Ref: FCC Class II Permissive change for FCC ID: HZB-8460
Original Grant date: 10/31/2002
Applicant: Proxim Corporation

This is to request a Class II permissive change for FCC ID: HZB-8460 , originally granted on 10/31/2002

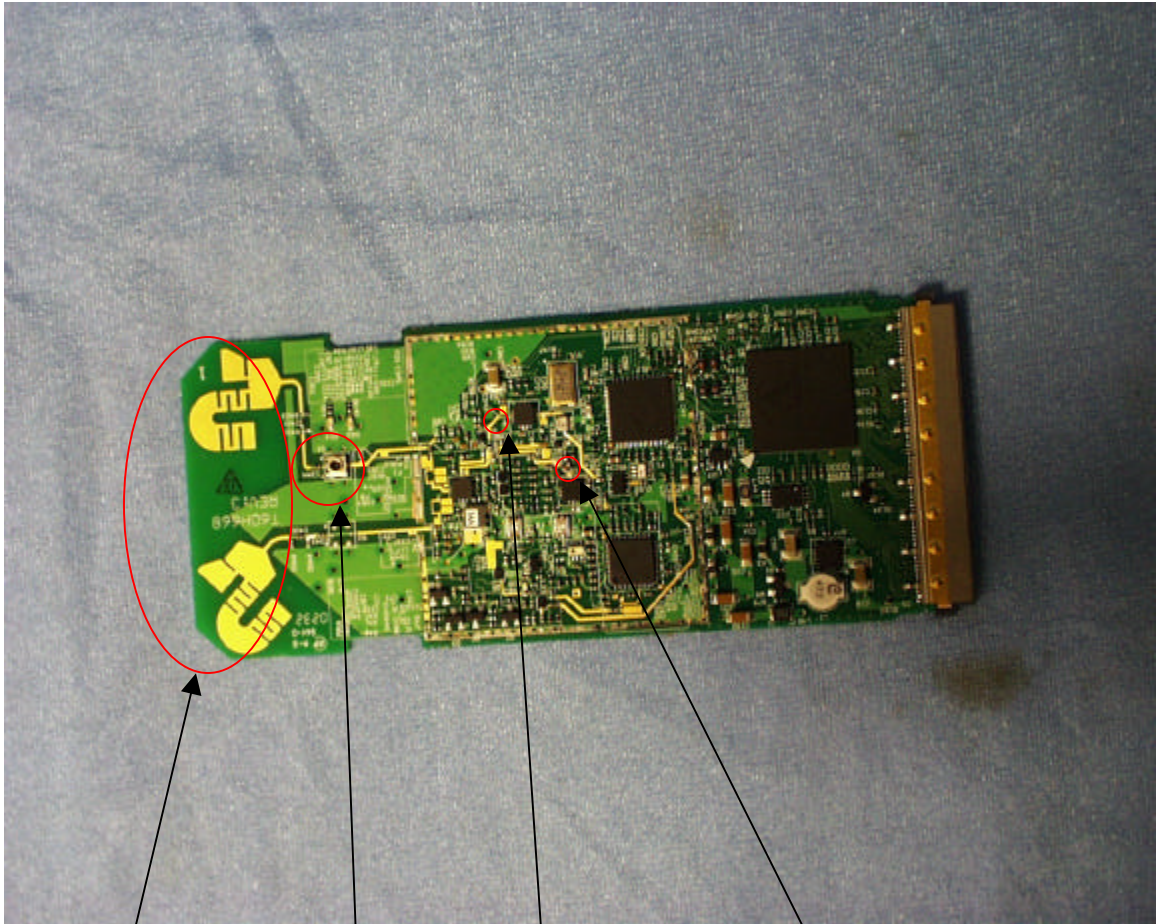
Change 1. The integral antenna was re-designed from a wire type to a printed circuit board antenna.

Change 2. A 0402 inductance 27nH (C342) was added to the power amplifier output to increase the amplifier linearity in the 5 GHz frequency band.

Change 3. A 0402 inductance 1nH (L400) and a 0402 capacitance 1.2pF (C403) was added to the power amplifier output to reduce the second harmonic and improve the mask in the 2.4 GHz frequency band.

Change 4. Change the test port location.

Change 1: Change
Antenna

Change 4:
Change the test
port location

Change 2: Add an
inductance

Change 3: Add an
inductance and
capacitance
